ENMIENDA NÚM. 2

SUBASTA FORMAL 23J-08957-R1 PARA MEJORAS AL PARQUE NORBERTO MONTOYO DE FLORIDA DEL DEPARTAMENTO DE RECREACIÓN Y DEPORTES DEL GOBIERNO DE PUERTO RICO

PARA MEJORAS AL PARQUE NORBERTO MONTOYO DE FLORIDA DEL DEPARTAMENTO DE RECREACIÓN Y DEPORTES DEL GOBIERNO DE PUERTO RICO

TRENCH SECTION DETAIL

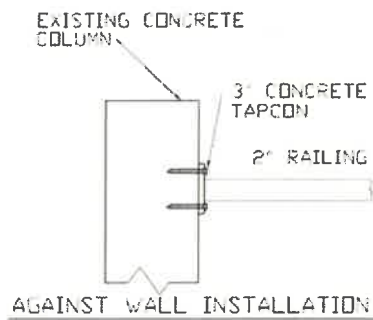
- H) The contractor must install a new 3-#4 RHHN underground electrical wiring. Use 2in min. diameter PVC SCHD. 40 conduits. See detail. (1,200 LF Approx.) Still considering the 200 LF of 1/0 main feeder.

Railing Detail

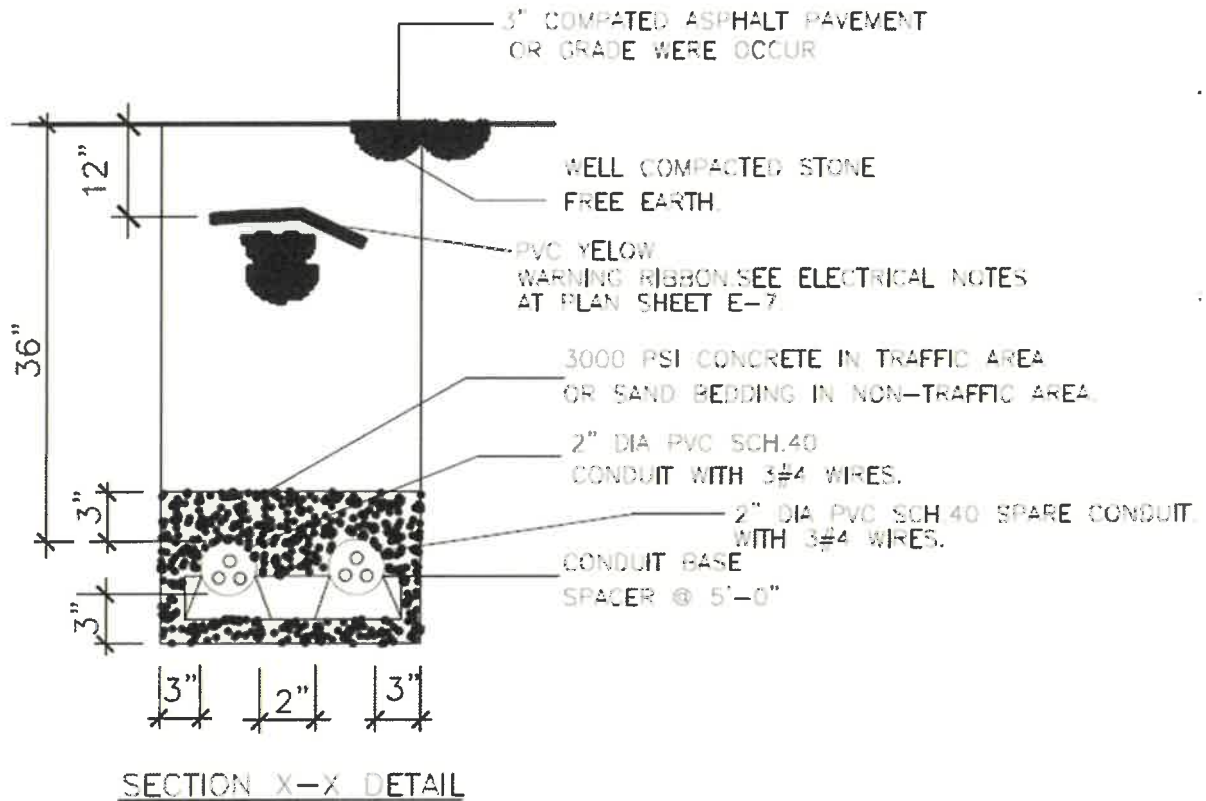
- 2) Install new handrail to existing bleachers and transmission station stairs. (374 LF). See detail. Two (2) rails.
- 3) Use three (3in) diameter poles for ten (10FT) and higher heights chain link fence. Use eight (8) FT max separation between poles.
